**TECHNICON DESIGN GROUP INC.**

DATE: OCTOBER 4, 2018**PROJECT NUMBER:** 72-2351-17**PROJECT NAME:** HEALTH PARTNER OF WESTERN OHIO - TIFFIN COMMUNITY HEALTH CENTER**INTENT:**

This Addendum provides modifications and clarifications To the Bid Documents dated **08/23/2018**. Bidder shall ascertain prior to submitting its Bid Form that it has received all Addenda issued and shall acknowledge receipt of each Addendum on the Bid Form.

END OF ADDENDUM 02

SHEET
E403

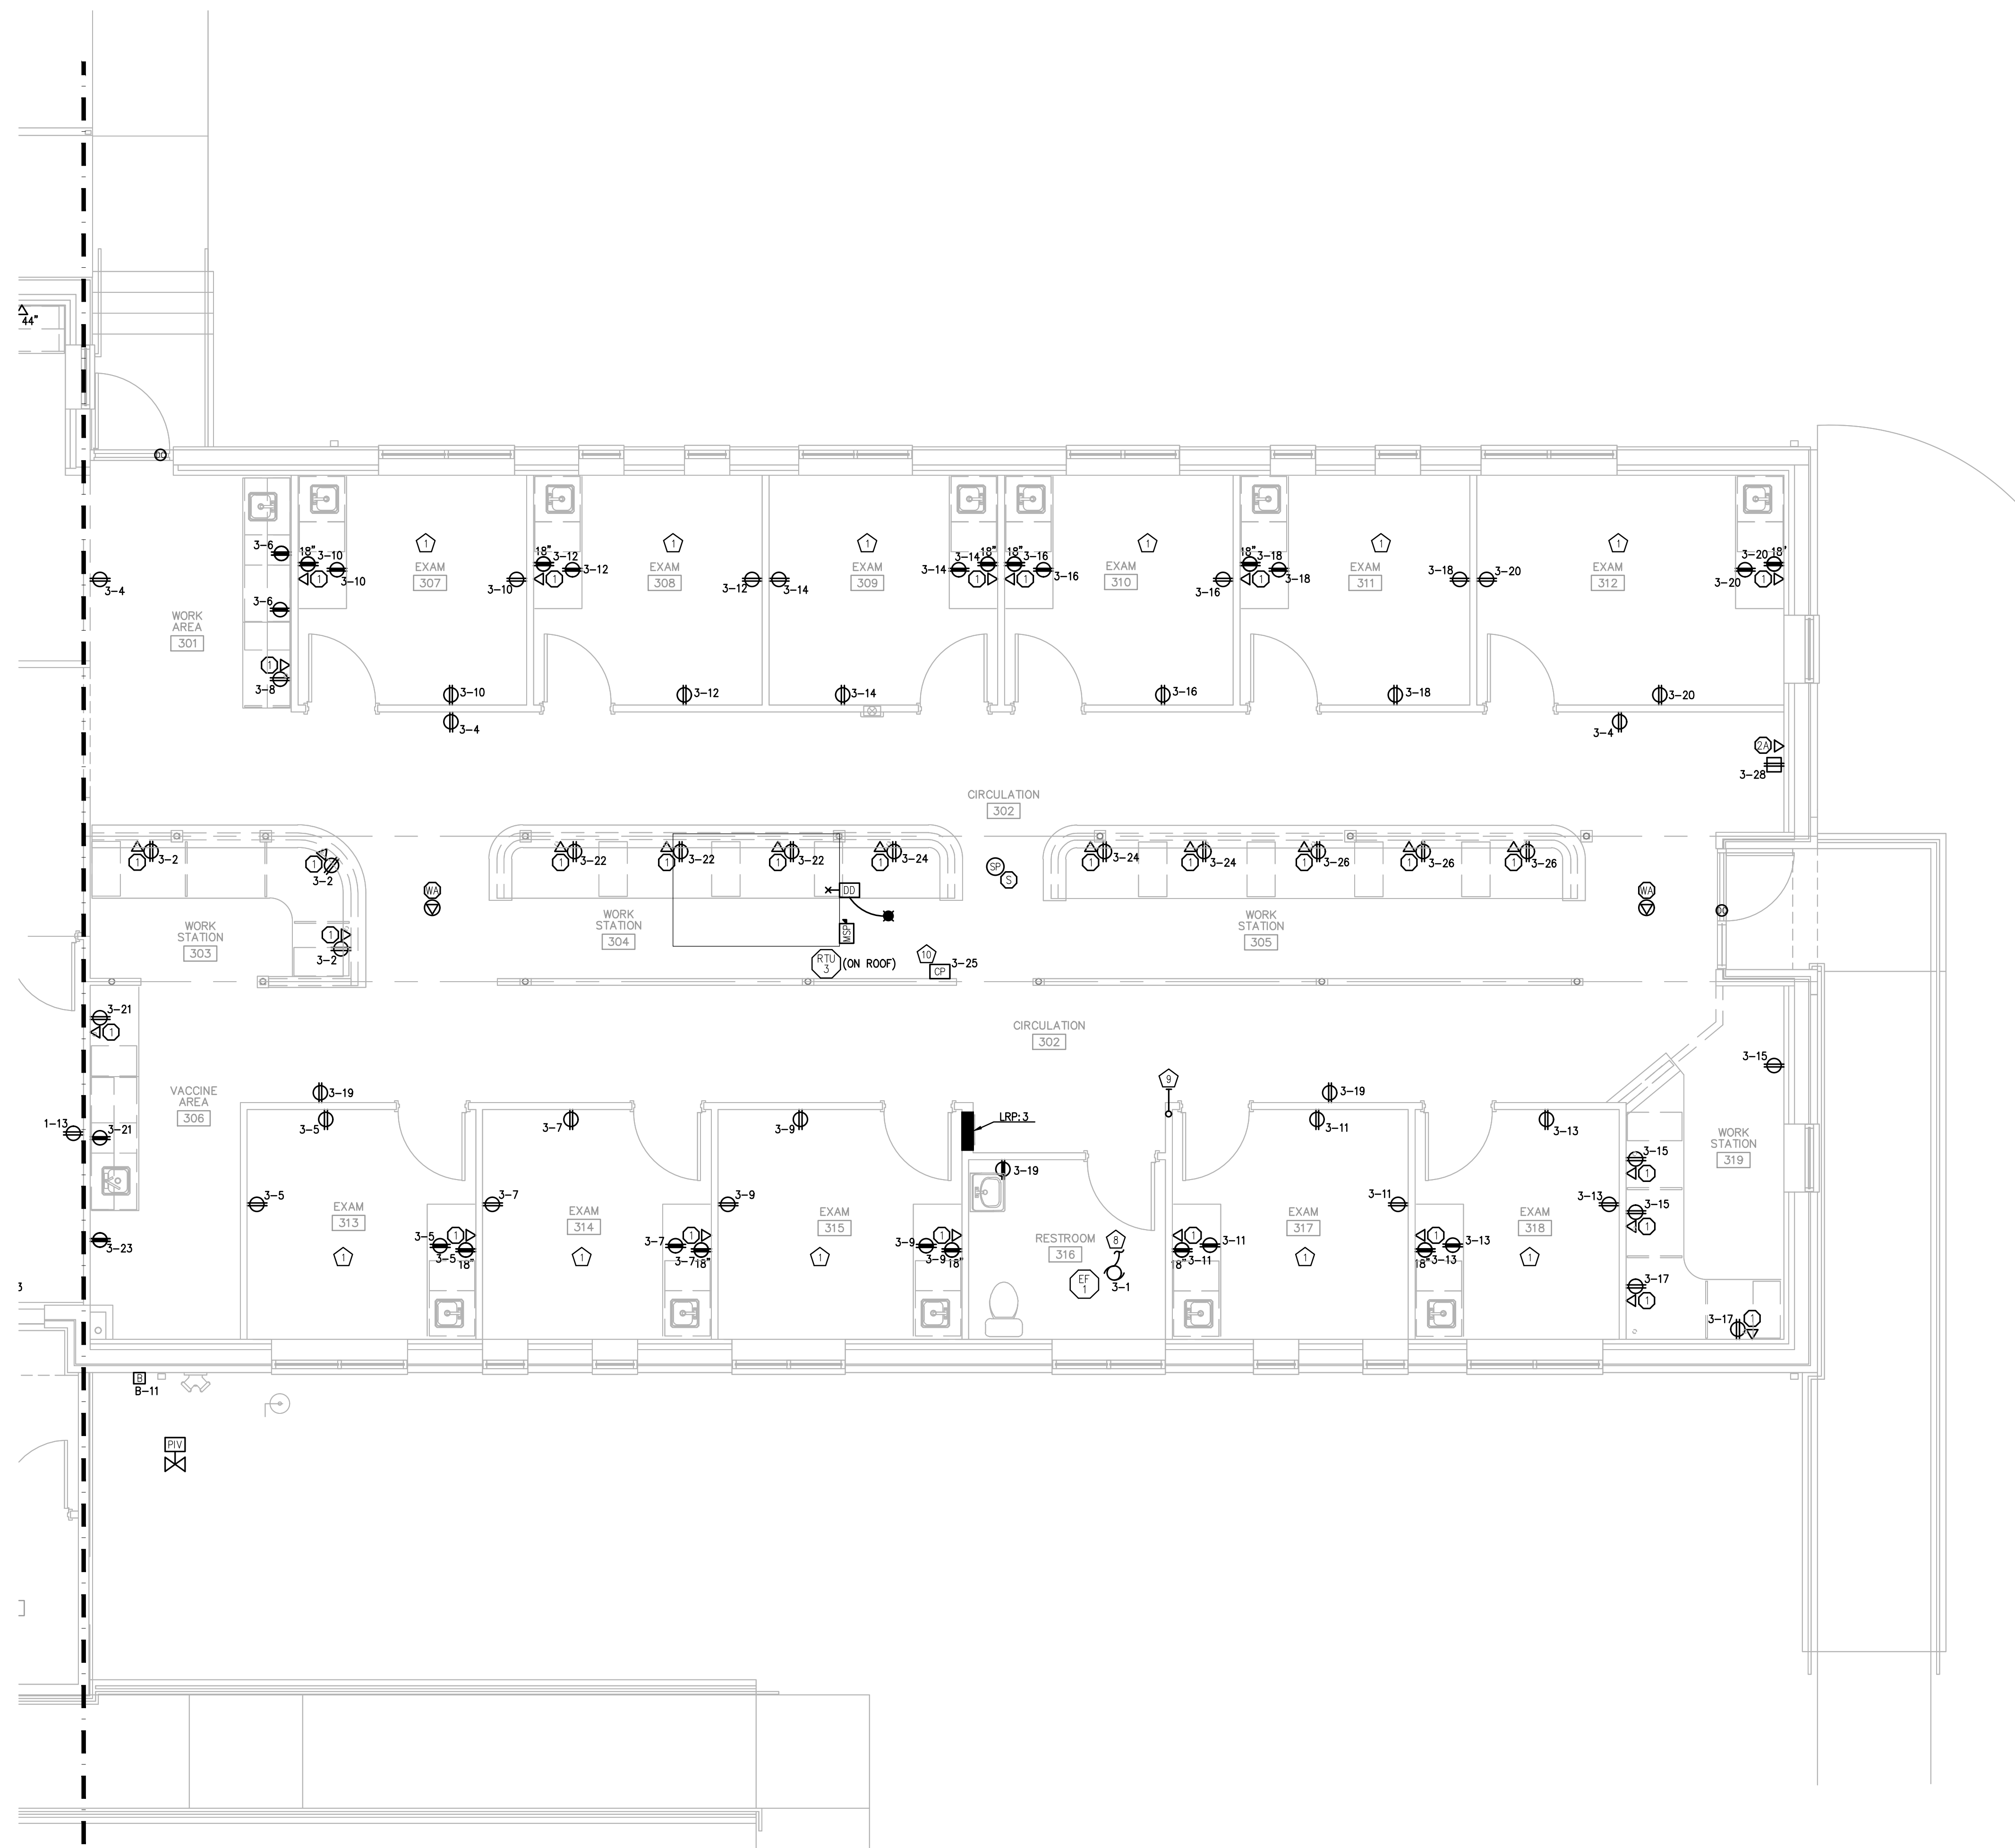
25	E401, E402, E403 09-27-18 ADDENDUM 02		Refer to sheet M400 Mechanical Specifications, Part 3.04, D, Accessories, Item #6: Provide power for unit mounted, factory wired GFCI, receptacles as required.
26	E401, E402, E403 09-27-18 ADDENDUM 02		FLOOR PLAN NOTES: Note #1; Revise 517.3 to 517.13. See revised drawing sheet.
27	E500 09-27-18 ADDENDUM 02		Added basement lighting circuits to Panel LRP:B panel schedule. See revised drawing sheet.
